<i>Cal Pacific Airmotive, Inc.</i>	Mandatory Service Bulletin	S.B. No. P51-001 Supplement No. 1
Title: Inspection of Flight Control System	North American Aviation P-51B, P-51C, P-51D, P-51K, F-51D, F-51K	Issue Date 5-1-2013 Page 1 of 2

Supplement No. 1

FIGURE 90- INSTALLING AILERON TRIM TABS REVISED UNDER LTC-11-5 MAY 1 2013

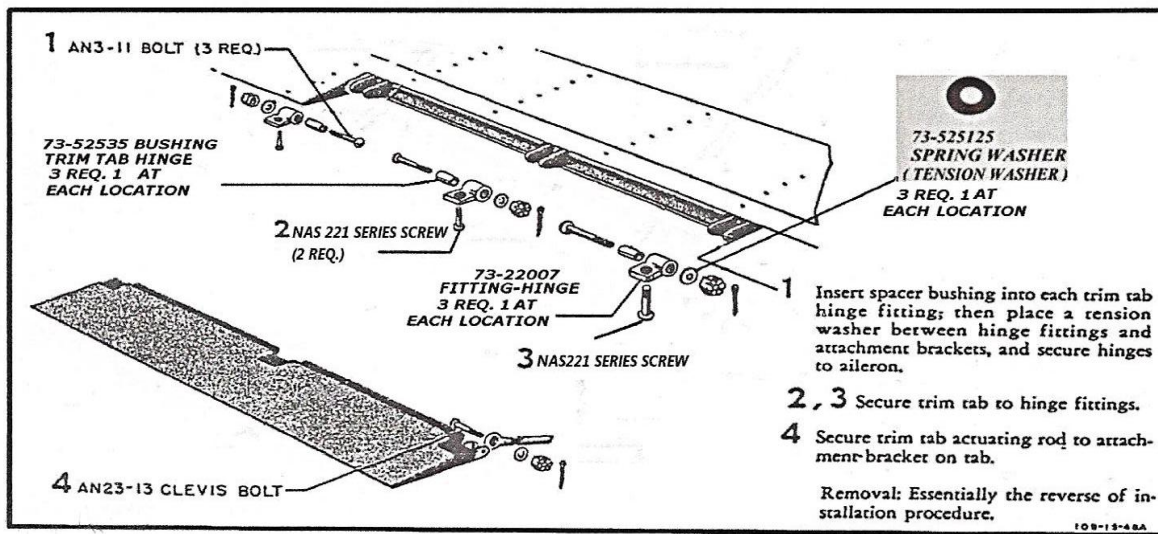
Supplement No. 1 to Service Bulletin P51-001 dated May 1, 2013 is to correct information contained in AN 01-60JE-2 Handbook Maintenance Instructions USAF Series F-51D, ZF-51K, F-51M, TF-51D dated December 20, 1944, revised December 20, 1952. Handbook page 84 figure 90 "Installing Aileron Trim Tab" incorrectly notes P/N NAS220-9 and NAS220-11 (8-32 thread structural screws) to be installed in spline nut P/N 22D8-02 (or 22ND8-02) 10-32 thread. This spline nut is installed in each of the trim tab hinge fittings P/N 73-22007.

- Attach this Supplement No.1 to Service Bulletin P51-001 dated May 1, 2013 to update page 7 figure 90 "Installing Aileron Trim Tabs" with figure 90 below to reflect the correct P/N NAS221 Series structural screw 10-32 thread.

1. Refer to Parts Catalog AN 01-60JE-4 USAF Series F-51D, TF-51D and F-51K Aircraft dated March 10, 1945, revised May 15, 1953, page 20D figure 4B "Aileron Assembly" index no. 33 to install the correct part number structural screw NAS221 series (10-32 thread). This parts catalog is also reference for the P-51D thru P-51K aircraft. Length of screw may vary from those published in the North American Aviation & USAF maintenance and parts manuals if trim tab is original, rebuilt, phenolic or metal covered.
2. When installing structural screws to secure the trim tab to the hinge fitting P/N 73-22007, make sure the screw shank does not bottom in the threads of the spline nut and at least one full thread extends through the locking nut insert.

- Apply the enclosed adhesive back revised figure 90 to AN 01-60JE-2 Handbook Maintenance Instructions for USAF Series F-51D, ZF-51K, F-51M, TF-51D dated December 20 1944, revised December 20 1952, page 84 figure 90 "Installation of Aileron Trim Tab" to reflect the correct structural Screw P/N NAS221 series 10-32 thread. Also update other manuals as may be deemed necessary.
- Use good maintenance practices to determine proper application of data from any USAF or NAA Technical Manual for P-51 series aircraft.
